VIRGINIA ELECTRIC AND POWER COMPANY
SURRY POWER STATION UNITS 1 AND 2
GENERIC LETTER 87-02 – UNRESOLVED SAFETY ISSUE (USI) A-46
REQUEST FOR ADDITIONAL INFORMATION

RESPONSE TO NRC RAI RE UNRESOLVED SAFETY
ISSUE (USI) A-46

Surry Power Station Units 1 and 2

RESPONSE TO REQUEST FOR ADDITIONAL INFORMATION GENERIC LETTER 87-02 SURRY POWER STATION UNITS 1 AND 2

Comparisons of In-Structure Response Spectra at 5% Spectral Damping and the
1.5 x Bounding Spectrum (Reference Spectrum) of the GIP

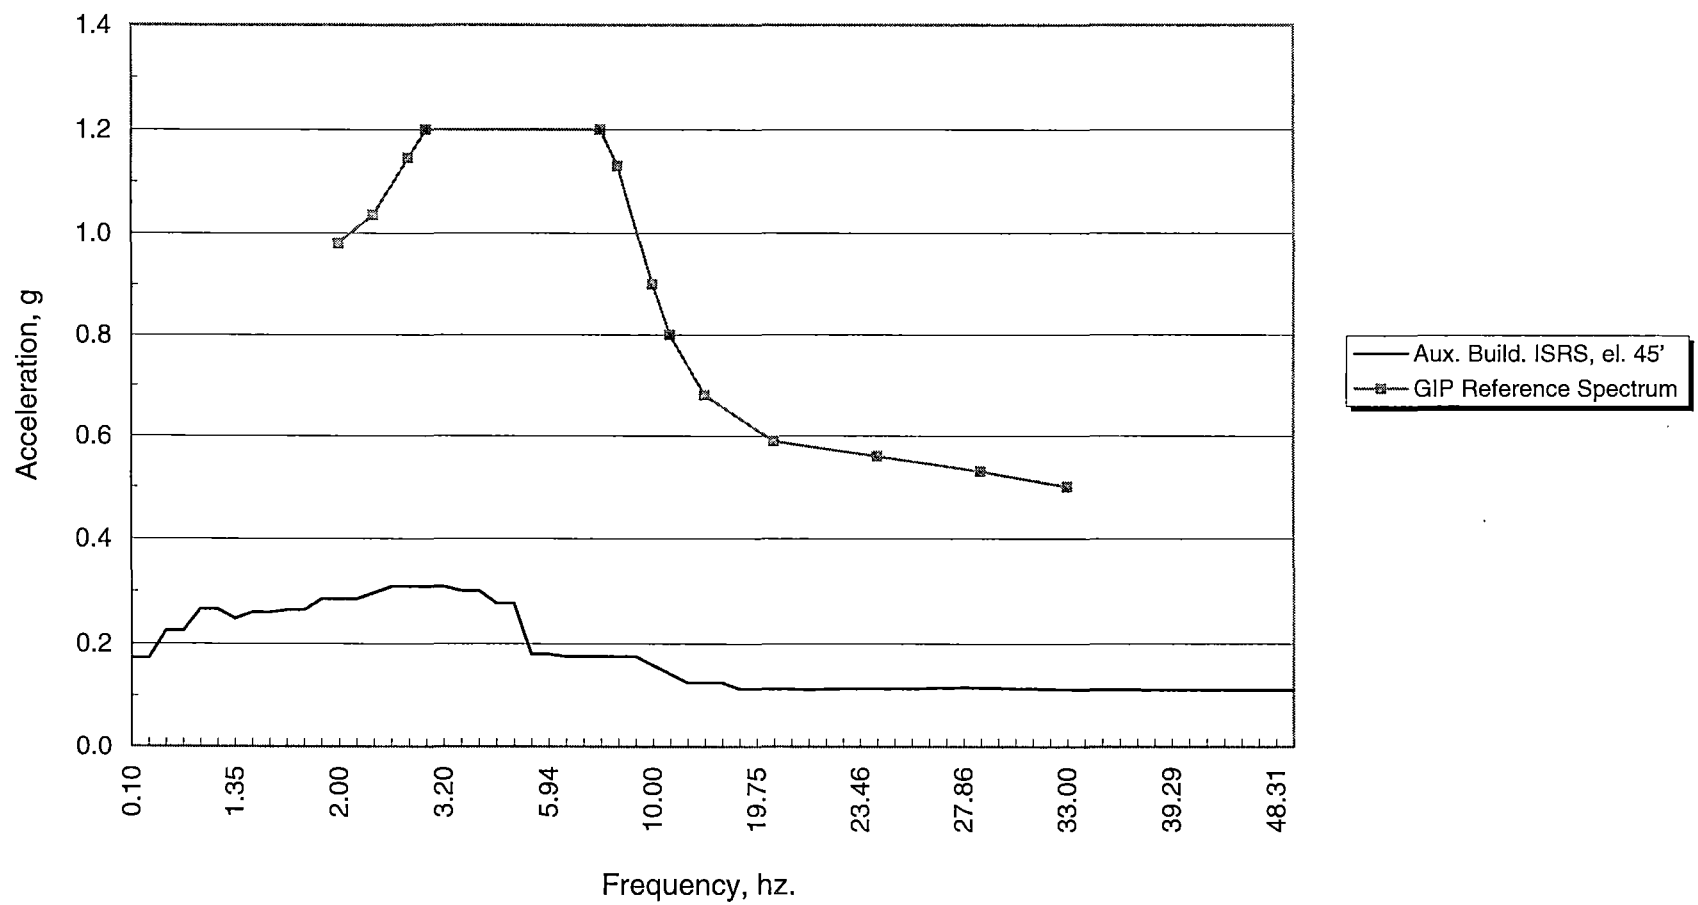
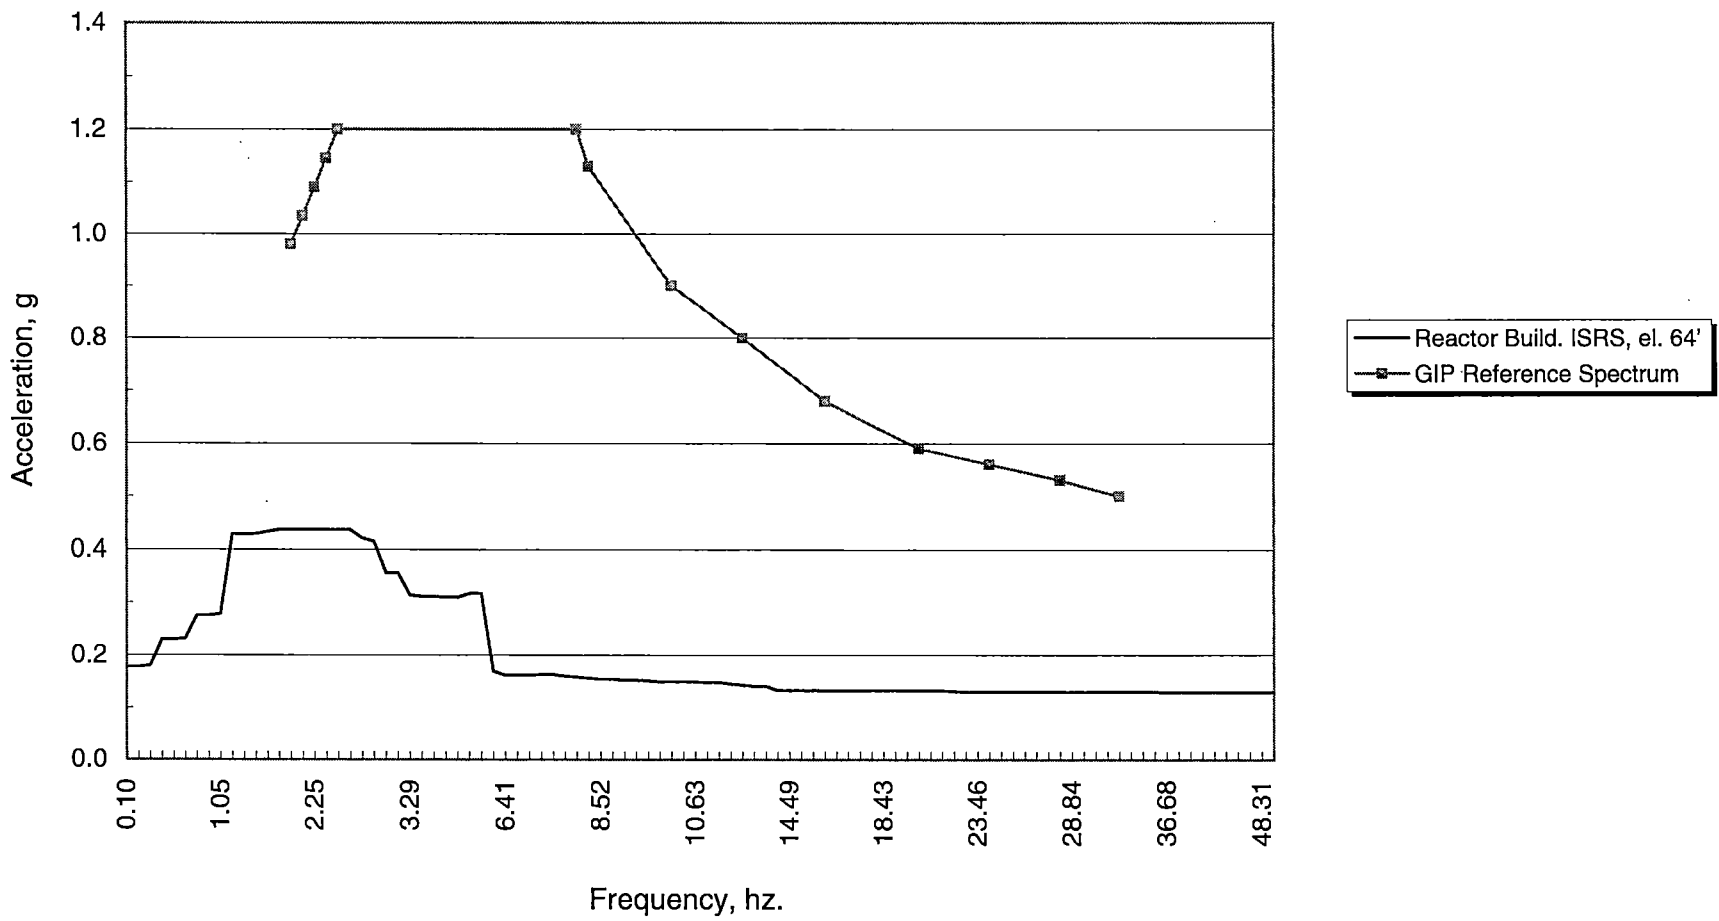
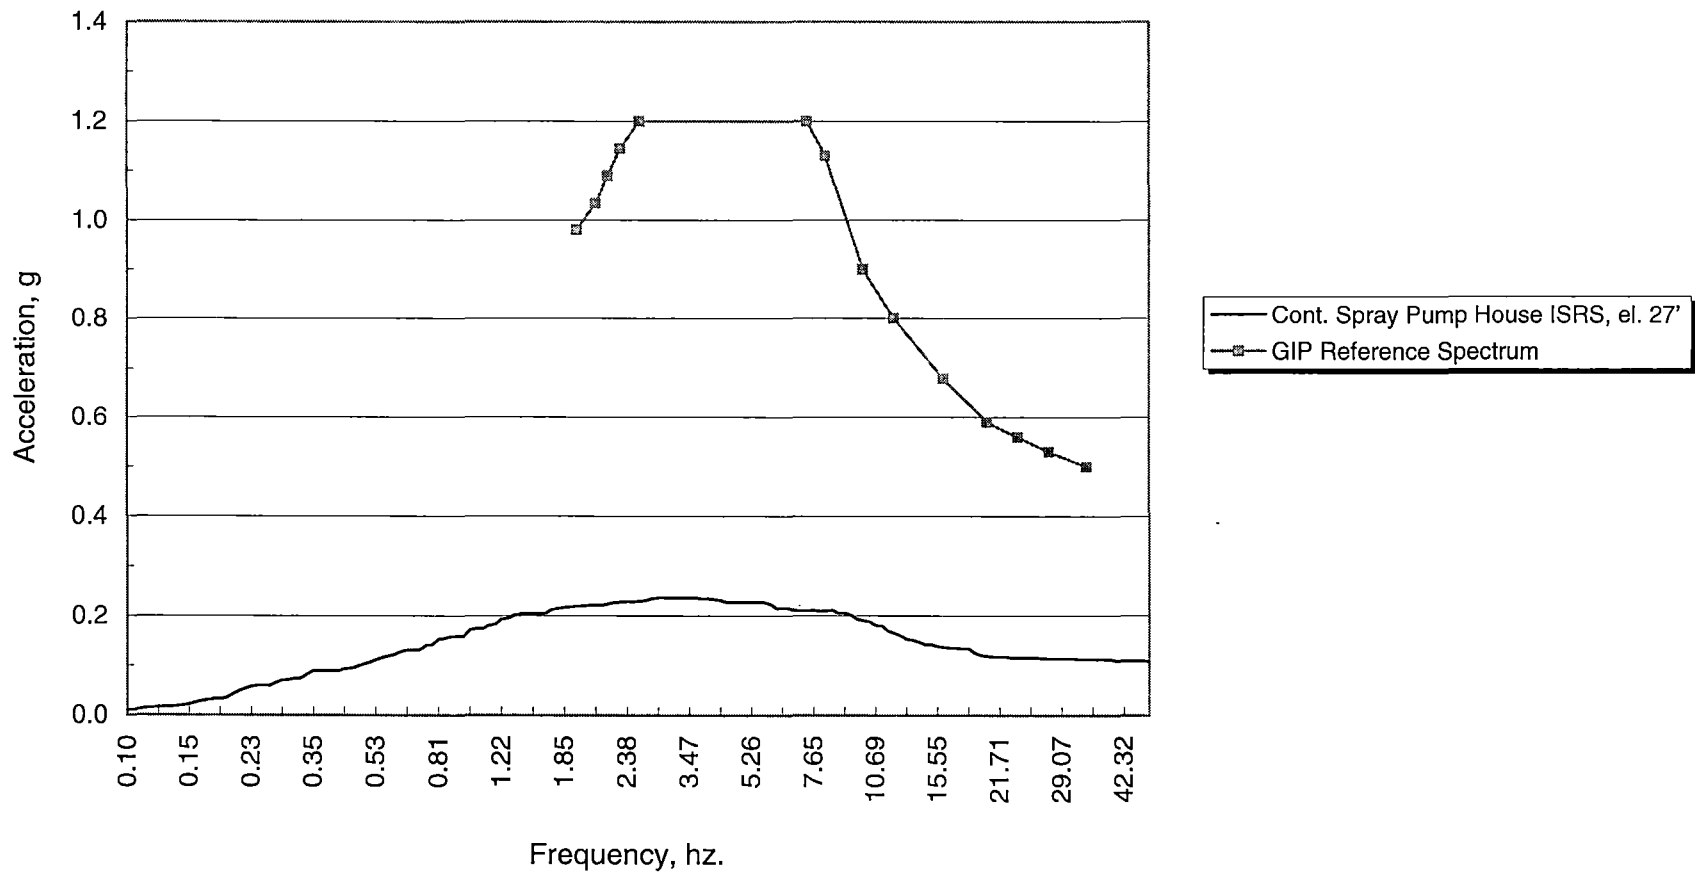
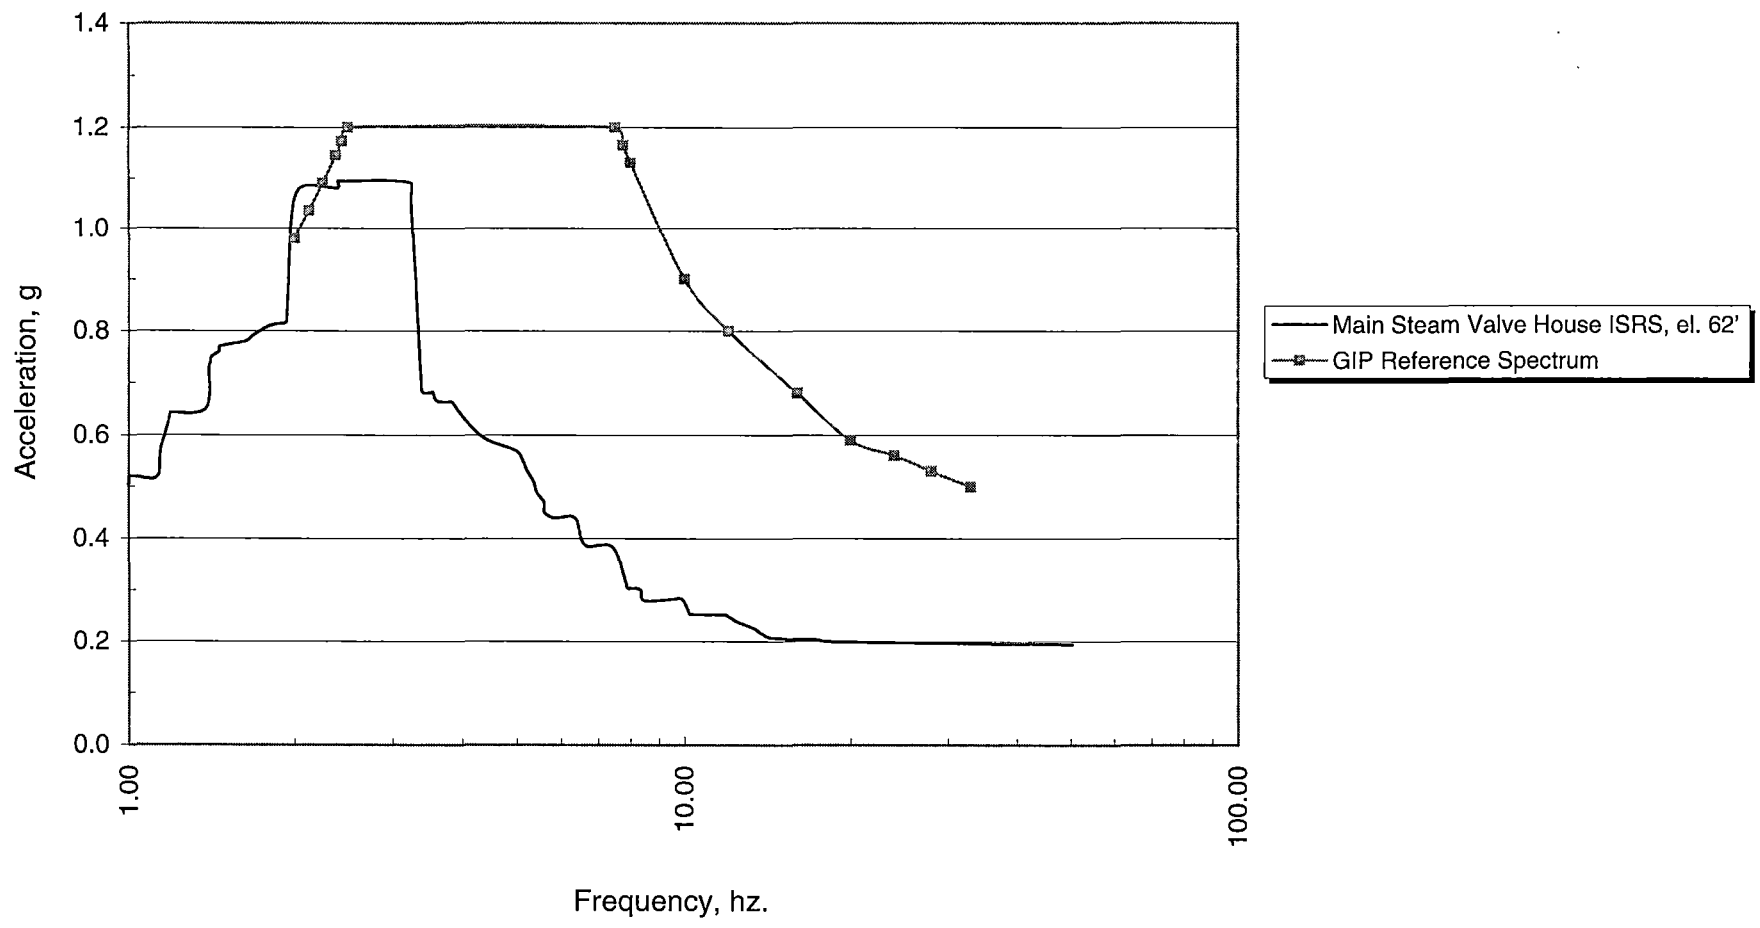
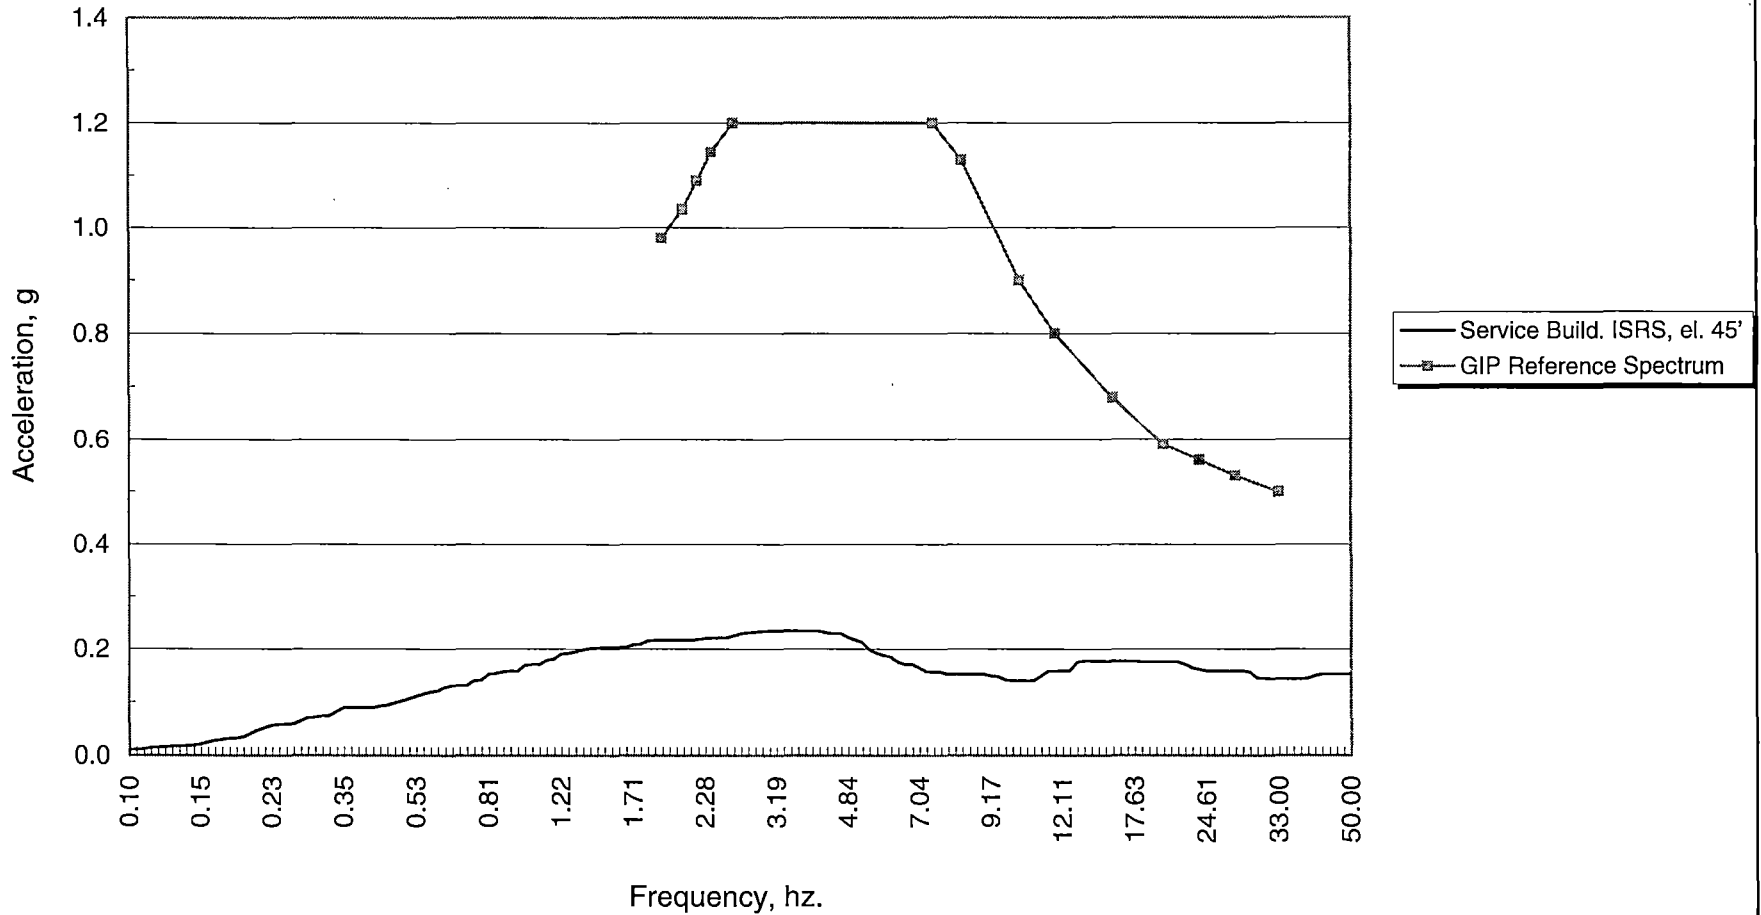
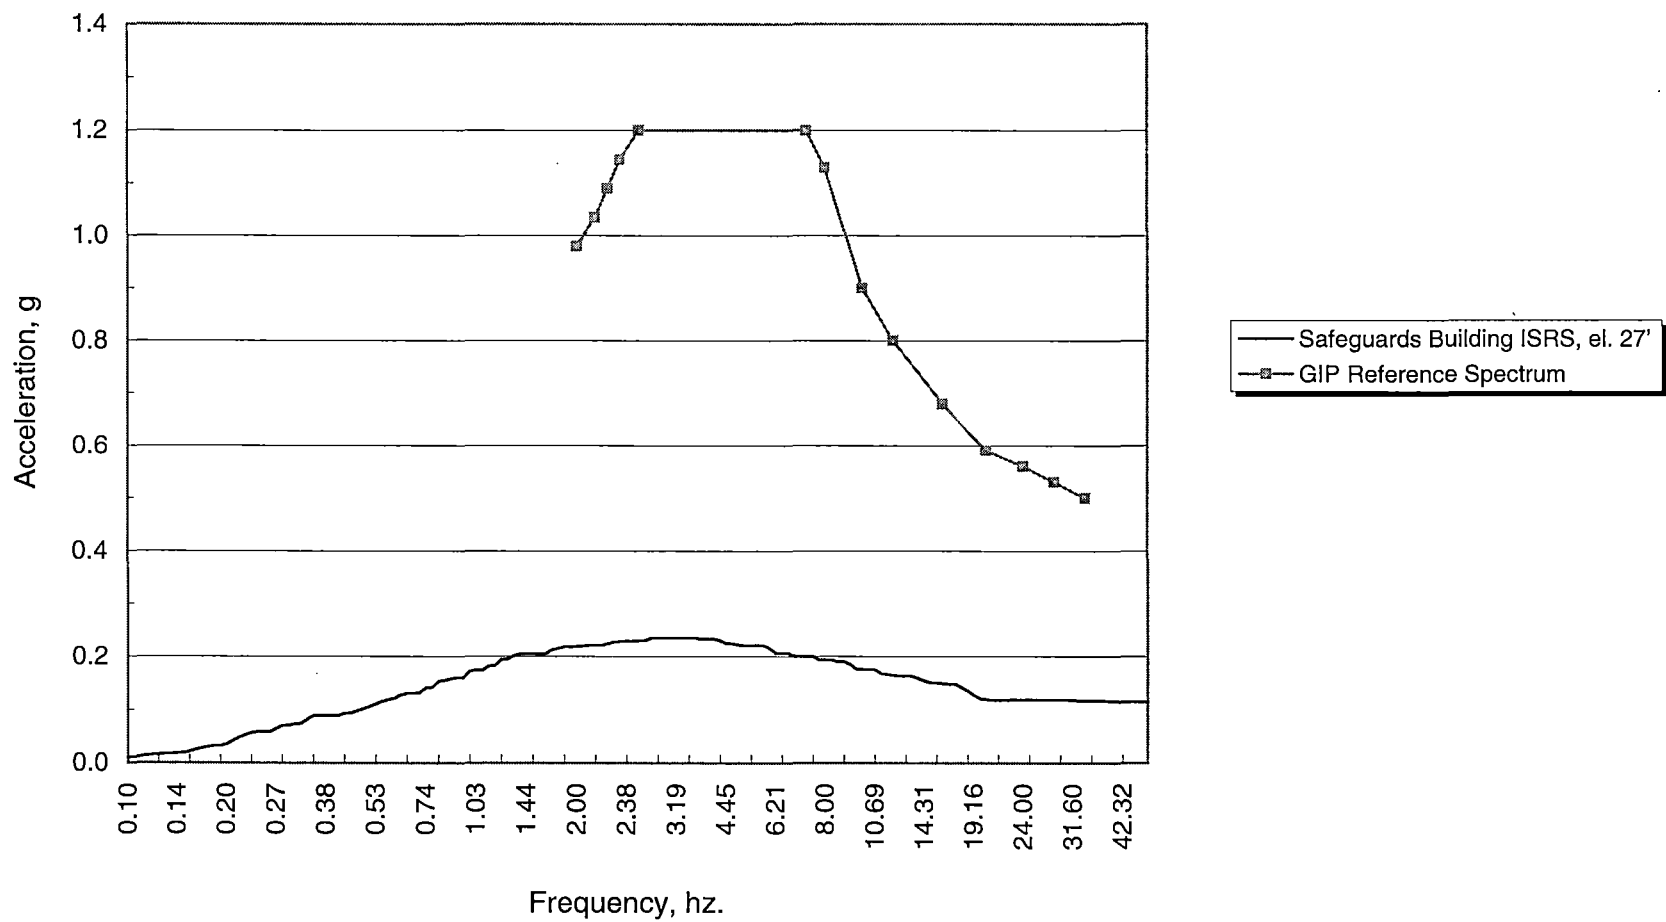
It is stated in the referenced submittal that for all buildings and elevations where (SSEL) equipment is located in the Surry plant, the in-structure response spectra (ISRS) are enveloped by the Reference Spectrum or the 1.5 x Bounding Spectrum of the GIP. You are requested to provide the ISRS at the highest elevations where SSEL equipment items are located in each building, and demonstrate their enveloping by the Reference Spectrum.

Comparisons of ISRS (envelope of both horizontal directions) at 5% spectral damping at the above locations and the 1.5 x Bounding Spectrum (Reference Spectrum) of the GIP are provided in Enclosure 2. This comparison demonstrates that the Reference Spectrum completely envelops the ISRS or meets the intent.

¹ Enveloping of ISRS of both the internal and the external structures is provided at this elevation.

² Peaks are extrapolated from 1% damping ISRS to obtain 5% damping ISRS for comparison with the Reference Spectrum. A few valves are located at elev. 62', and a slight excursion near 2 hz. is judged to meet the intent of GIP.

³ The Emergency Diesel Generator Rooms are included in the model for the Service Building. It is also noted that the Reactor Trip Breakers are located in this building at elevation 45' within a compact structural hut. Although they are top braced to the hut at elevation 54', the ISRS at elevation 45' was judged to be applicable. This is the highest elevation in this building containing any SSEL equipment item.

⁴ No new analysis was done for the Turbine Building to generate ISRS. The conservative, design ISRS at all elevations in this building is based on the Taft earthquake input and was developed in the 1971 time frame for 1% spectral damping. From this, ISRS at 5% spectral damping was recently developed, and is compared with the 5% damped Reference Spectrum of the GIP. A slight exceedance near 2 hz is judged to meet the intent of the GIP.

⁵ No Housner basis design ISRS was developed for this structure. A study concluded that the ISRS is not larger than 1.2 times the ground spectrum at the highest elevation where SSEL components are located in this building.

⁶ This is a compact structure, and SSEL components are located below the grade level. Therefore, the ISRS is judged to be less than 1.2 times the ground response spectrum.
